**Technical Support Document**  
**for EPA's**  
**Proposed Action on the**  
**Louisiana Regional Haze State Implementation Plan**

**April 2017**

Figure 1. Rodemacher BOD SO<sub>2</sub> Emissions

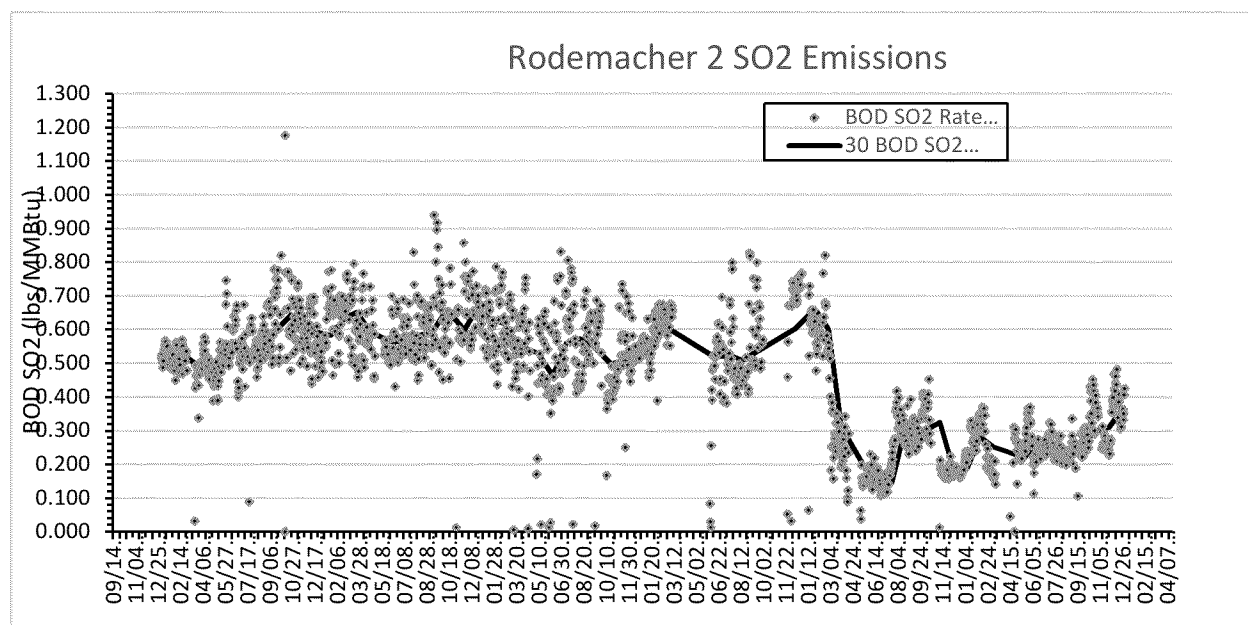
As the above figure indicates, the Rodemacher 2 DSI system became operational on approximately 3/1/15, and that the current system is capable of achieving SO<sub>2</sub> emissions of approximately 0.4 lbs/MMBtu or less for sustained periods of time. Cleco determined that the current and enhanced DSI systems have SO<sub>2</sub> removal efficiencies of approximately 39% and 63%, respectively, with the enhanced DSI system being capable of a monthly SO<sub>2</sub> emission limit of 0.30 lbs/MMBtu. Cleco secured this limit as part of the same AOC referenced above for the Nesbit 1. We believe that based on the information we have presented in Figure 1, Louisiana's selection of 0.30 lbs/MMBtu on a rolling 30 day basis for SO<sub>2</sub> is reasonable for an enhanced DSI system on the Rodemacher 2.
